# APSU behavior upon loss of signal

Adee Ran, Cisco

# Background and goal

Figure 178B-10—Training control state diagram

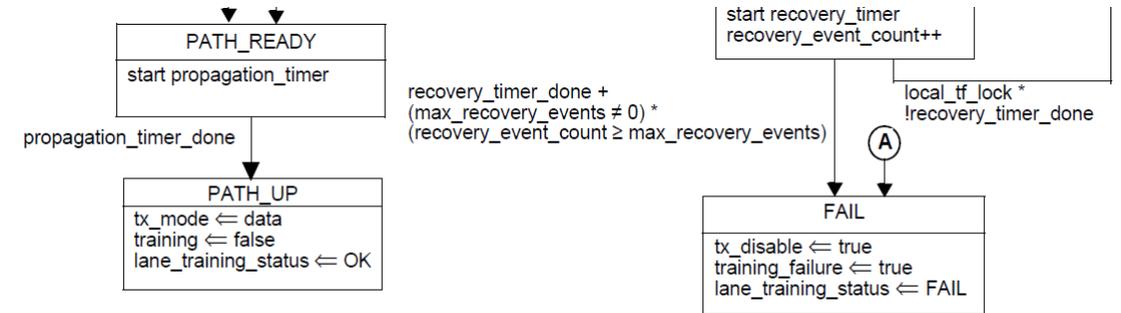
Lane\_training\_status is set in PATH\_UP  
This is a terminal state!  
status will stay OK until mr\_restart

➔ We need to add some way to change lane\_training\_status to FAIL on an active link

Proposed addition to Figure 178B-10

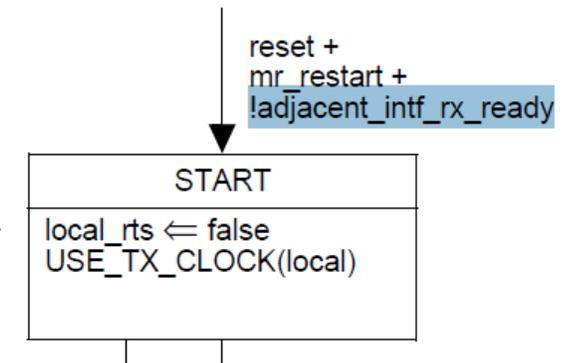
To handle disruptions, a new state (LOSS\_OF\_SIGNAL) can be added to the training control state diagram.

Entering this state (in any of the lanes) will cause:

1. **lane\_training\_status** ← FAIL
2. **training\_status** (per-interface aggregate of lane\_training\_status) ← FAIL.
3. **rts\_status** ← FAIL (per definition).
4. **SIGNAL\_OK** parameter of **inst:IS\_SIGNAL.(indication/request)** is FAIL (reflects rts\_status).
5. This gets communicated to the adjacent interface via **inst:IS\_SIGNAL.(request/indication)**.
6. **adjacent\_signal\_ok** ← FAIL of the adjacent interface (per definition).
7. RTS update state diagram of the adjacent interface transitions to START, sets **local\_rts** ← false and uses local clock (see below).

Optional addition to Figure 178B–10

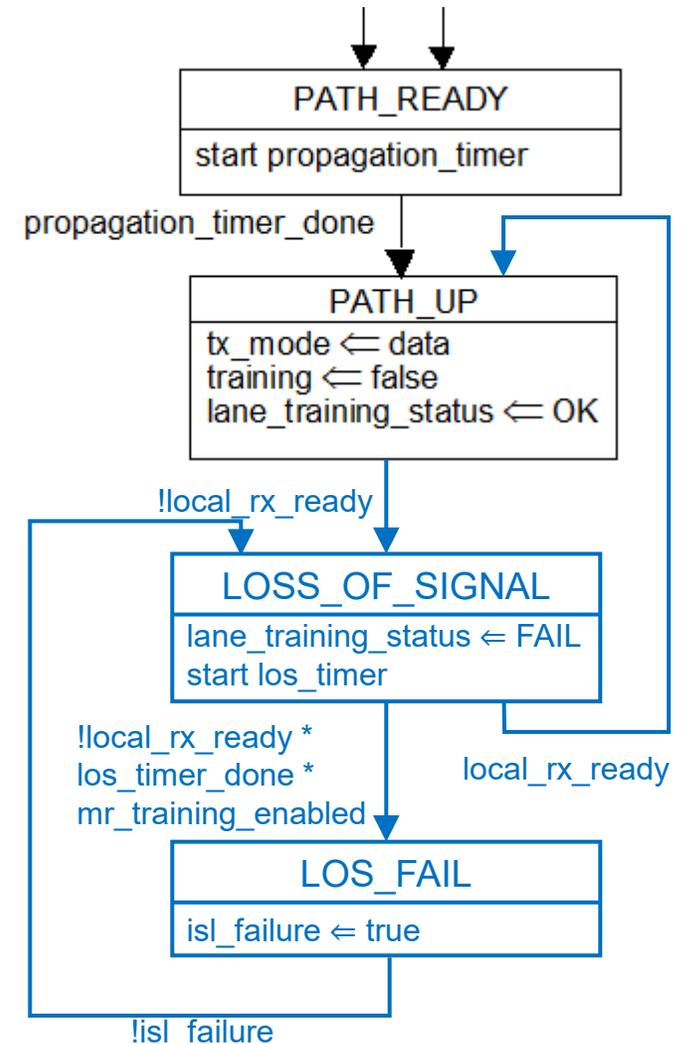
The suggested additional states shown on [slide 12](#) result in LOS\_FAIL being a terminal state. Recovery from LOS\_FAIL requires restart of training (by management).

It may be desirable to enable recovery from this state without re-training – **let management decide if it is a failure or not.**

One way to achieve that is by adding a transition as shown on the right, with a new indication variable “isl\_failure” that is R/W, such that management can reset it.

- This would enable recovery from LOS\_FAIL by high-level management (e.g. CMIS host) without restarting training – for example, if the PCS has re-acquired AM lock.
- High-level management is also able to restart training on an ISL using mr\_restart, for example, if the PCS has lost AM lock for an extended time.
